New! Optional Tall Rear Shock Tower for the RC10B6 & B6D

#91666 B6 Rear Shock Tower (Long)

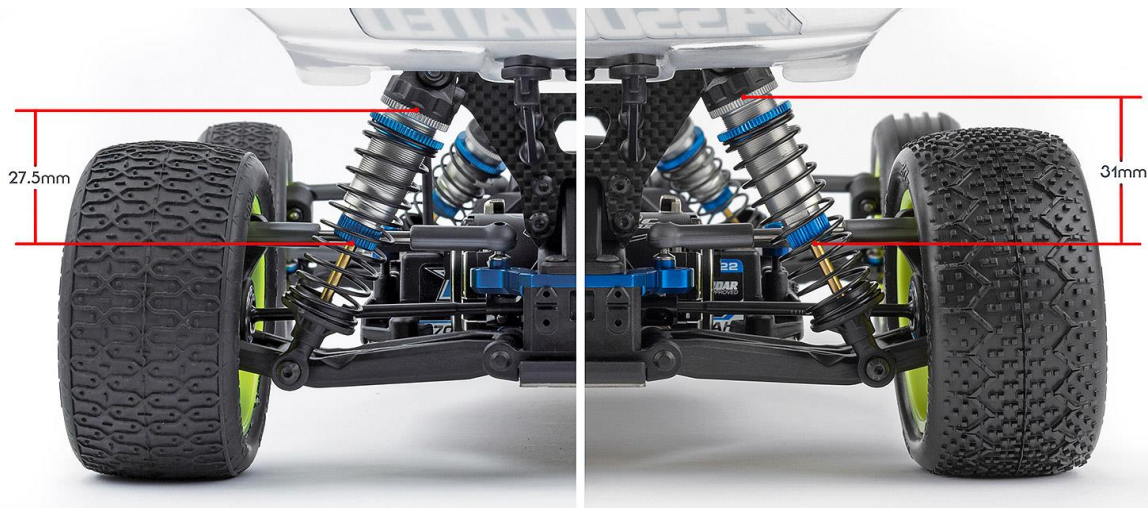
Arrow shows hole added to distinguish this optional tower from the standard tower

The optional, tall rear shock tower allows your RC10B6 and RC10B6D to accommodate longer, higher-capacity 31mm shocks (the same shocks that come on the B5 series) for better compliance on very bumpy or loose tracks.

For comparison: Left: standard #91665 shock tower. Right: optional #91666 shock tower.
